Kay C. Havenor, Ph.D

July 18, 2008

Subject: BLM letter re: Mesquite SWD, Inc. #8 Exxon State SWD well dated June 9, 2008

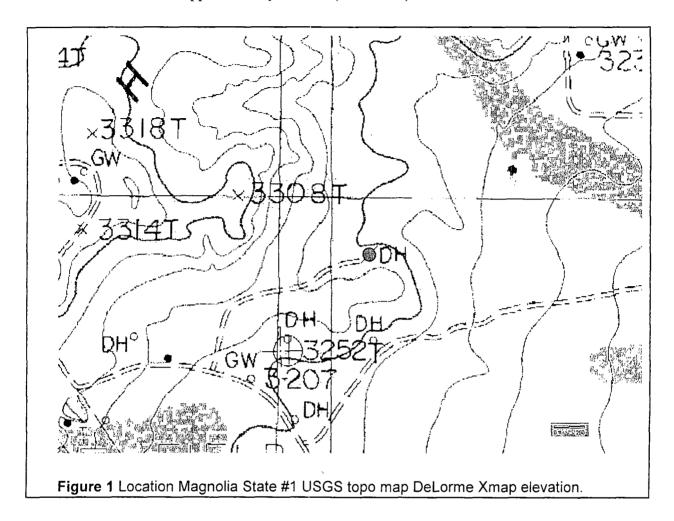
All the above seems trivial but does provide facts related to the inference that the Mesquite SWD well is responsible for crude oil bubbling out at the surface around the Magnolia State # 1 located N46°E approximately 2,935 ft (0.56 miles) northeast.

The top of the Magruder in the Mesquite SWD #8 Exxon is at +2720 MSL, ten feet lower than the Magnolia State #1 at +2730 MSL. The base of the casing cement in the Mesquite SWD well is at 574' (+2707 MSL). The USGS Topo ground surface elevation of the Magnolia State #1 is 3256 ft as shown in Figure 1. The subsurface elevation of the Magnolia's 538' TD is +2718' MSL. The bottom of the cement behind the geophysically logged casing in the Mesquite SWD well is at 574' (+2707' MSL), or 11 feet below the deepest depth drilled in the Magnolia well. Therefore, the same stratigraphic oil and water zone in the Magnolia at 533 - 538' (TD) is cemented behind casing in Mesquite's SWD well. The Magnolia zone is not only over ½ mile away, it is also stratigraphically 11 ft above the uppermost horizon shown on tracer tests in the Mesquite SWD well to be accepting any disposal water.

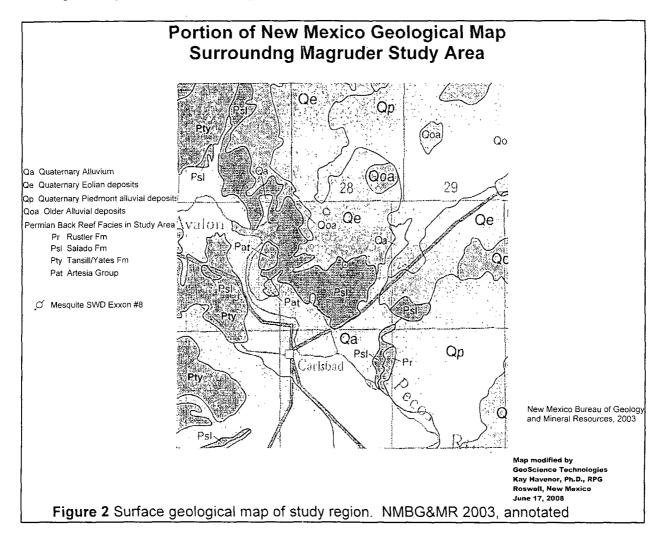
In the BLM reference to the Salado Formation they state that it is "an evaporite sequence that is primarily salt." Figure 2 is approximately a 9 township cut from the New Mexico Bureau

Figure 2 shows the location of the Mesquite SWD well (approximately in center of map). It is plotted close to the northern edge of the Salado Formation outcrop. We are fortunate in that Mr. Rains, the original operator and driller of the well, kept and reported a detailed sample descriptions during drilling the well. A copy of his driller's log has been included in the C-108 application to which the CFO of the BLM protested. Mr. Rains explicitly reported, on two lines, that no salt was encountered in drilling the hole. Mr. Rains reported redbeds and sand from the surface to 40 ft, gypsum and redbeds from 40 to 75 ft, then hard gray dolomite and anhydrite. The probability is greater that the Magruder Field is predominately on uppermost Artesia Group Tansill outcrops rather than Salado. Salado Formation in this area and north is devoid of salt beds.

The BLM states the CFO is particularly concerned because of the shallow injection depth of the Exxon State #8 "and its proximity to the Pecos River and the City of Carlsbad." Reference to Figure 2 readily shows that the Exxon State #8 is approximately 6 miles northeast of the City of Carlsbad, and over 5 miles east of the Pecos River. Not only is the distance significant, but the real directions of groundwater gradients are opposed to the BLM's concern as to how water would move—which it cannot. In addition, the Magruder Field is clearly in the back-reef environment whereas the City of Carlsbad is literally on the reef. The lithologies present in the Magruder Field gradually transition southward of the study area into back-reef carbonates that were deposited behind the reef. The sandstones and anhydrites tongue-into the reef about 3 to 5 miles south of the Magruder Field. The back-reef facies are a different world from the reef facies. It is important to also note that the reef facies is where the high transmissivity zones of the Capitan reef occur.
